METROPOLITAN GOVERNMENT OF NASHVILLE AND DAVIDSON COUNTY

Metropolitan Historic Zoning Commission
Sunnyside in Sevier Park
3000 Granny White Pike
Nashville, Tennessee 37204
Telephone: (615) 862-7970

STAFF RECOMMENDATION
920 West Eastland Ave
June 17, 2020

Application: New Construction—Infill and Outbuilding
District: Greenwood Neighborhood Conservation Zoning Overlay
Council District: 06
Base Zoning: RS.5
Map and Parcel Number: 0820801300
Applicant: Paul Martin
Project Lead: Melissa Baldock, melissa.baldock@nashville.gov

Exterior Elevation Front

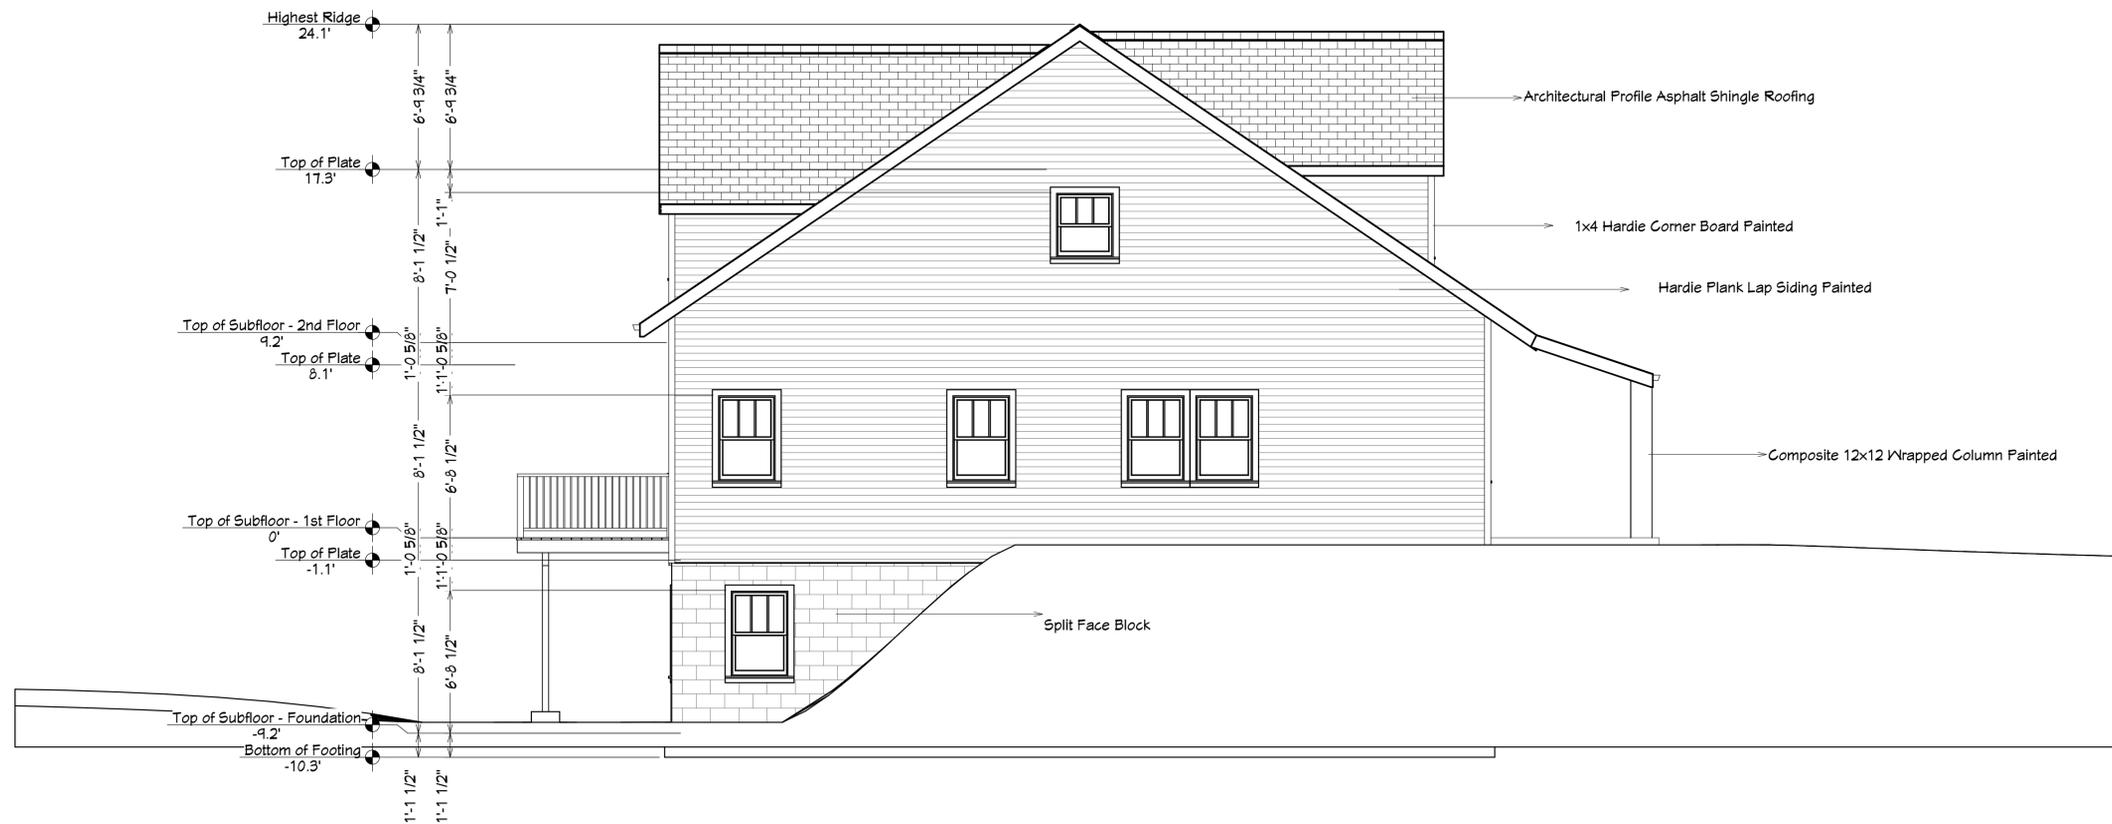
Height & Scale: The proposed infill is one-and-a-half stories tall, with a maximum height of 24'1" from grade at front. Staff finds that this meets the immediate context where historic houses are one and one-and-a-half stories tall with heights ranging from eighteen to twenty-four feet (18'-24') from grade. However, the infill is drawn as if it does not have an above-grade foundation at the front, and staff recommends that the drawings be revised so that the minimum foundation is shown on the elevations and the house be no taller than 24'1" above grade at the front. Houses in the immediate vicinity have minimal visible foundations as the front. The eave height is about nine feet, six

*The front porch columns were drawn without caps and bases, and staff recommends that the front porch columns have caps and bases.

Roof form: The infill’s main roof form is a side gable with an 8/12 pitch. The infill includes a front gabled dormer. Staff finds that the proportions of the dormer do not meet the proportions of historic dormers. Staff recommends that the dormer be brought off the ridge of the house by at least three feet (3’) and designed so that the windows take up more of the front face of the dormer, as was typical of historic dormers. The two gabled rear dormers meet the design guidelines.

Proportion and Rhythm of Openings: As mentioned under “Roof Form,” the dormer window proportions are not typical of historic dormer windows, and staff recommends that the dormer be brought off the roof ridge by several feet and that the windows of the dormer fill up more of the front face of the dormer.

With the condition that the front dormer be redesigned to better match the proportions of historic front dormers, staff finds that the infill’s roof form to meet Section II.B.1.e. of the design guidelines.

With the requested alterations to the front dormer, staff finds the project’s proportion and rhythm of openings to meet Section II.B.1.g. of the design guidelines.

1. The finished floor height shall consistent with the finished floor heights of the adjacent historic houses, to be verified by MHZC staff in the field;
2. The drawings accurately show the foundation at the front, and the height of the house from grade at the front be no taller than 24' in elevation;
3. The front dormer be reduced so that it sits at least three feet (3') off the ridge of the house and its windows take up more of the dormer's front face;
4. The front porch columns have simple caps and bases;
5. Staff approve the windows, doors, front porch material, roof shingle color, and driveway and walkway materials;
6. The HVAC shall located behind the house or on either side, beyond the mid-point of the house; and
7. Any overhang on the garage be just over the doorway, extending no more than two feet (2') from either side of the door, and no more than three feet (3') deep.

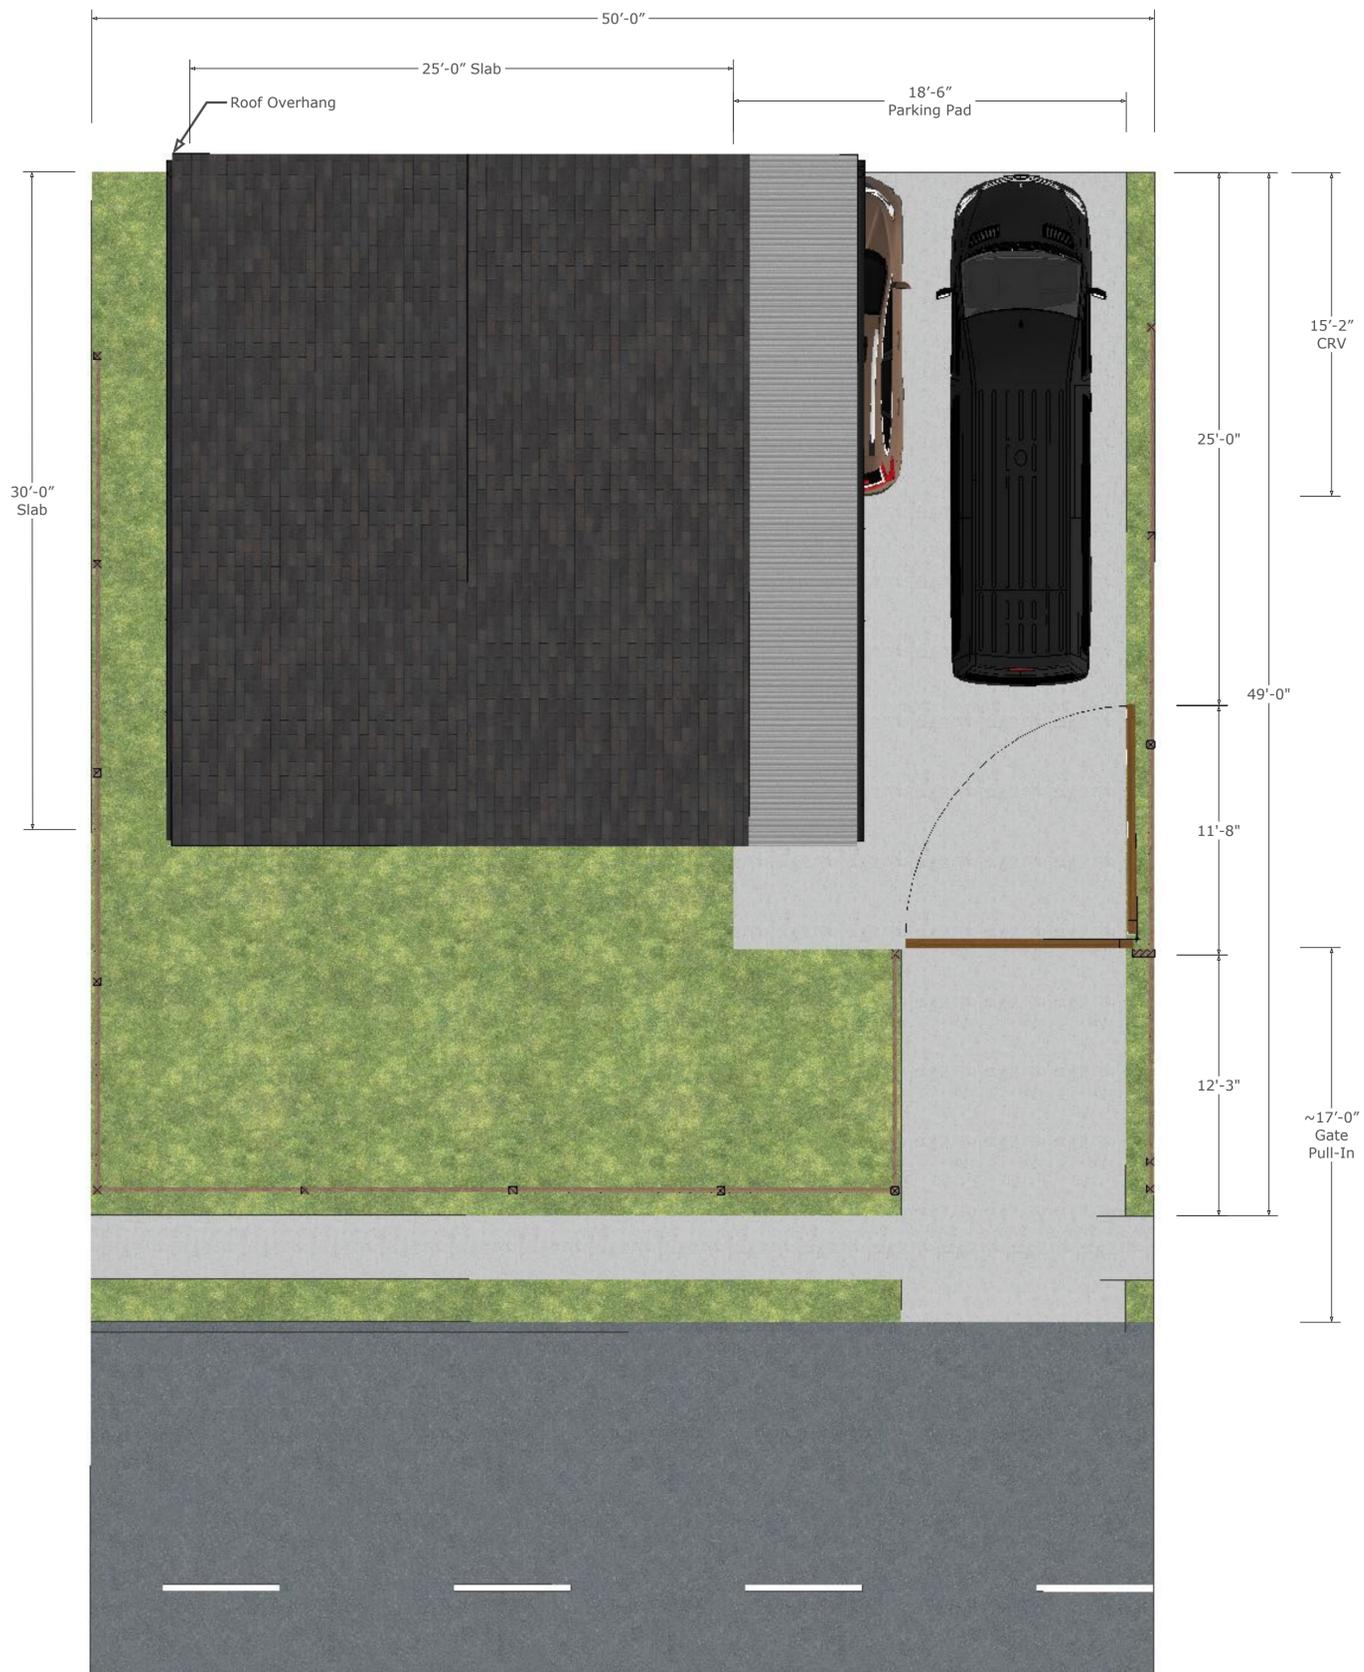
Design Standards: The accessory structure has a simple, utilitarian design that is appropriate for outbuildings. Its roof form, detailing, and form do not contrast greatly with the primary structure. The garage will be visible from Cleveland Street, as is the rear accessory structures of all the houses on this side of West Eastland. The location at the rear of the lot is appropriate. The proposed overhang is five feet, ten inches (5’10”), which staff finds to be too large as it is almost providing covered parking, exceeding the seven hundred and fifty square foot (750 sq. ft.) footprint. Staff recommends that any overhang should just be over the doorway, extending no more than two feet (2’) from either side of the door, and no more than three feet (3’) deep.

With the condition that any overhang on the garage be just over the doorway, extending no more than two (2') feet from either side of the door, and no more than three feet (3') deep, staff finds that its height, scale, setbacks, location, and overall design meet Section II.B.1.h. of the design guidelines.
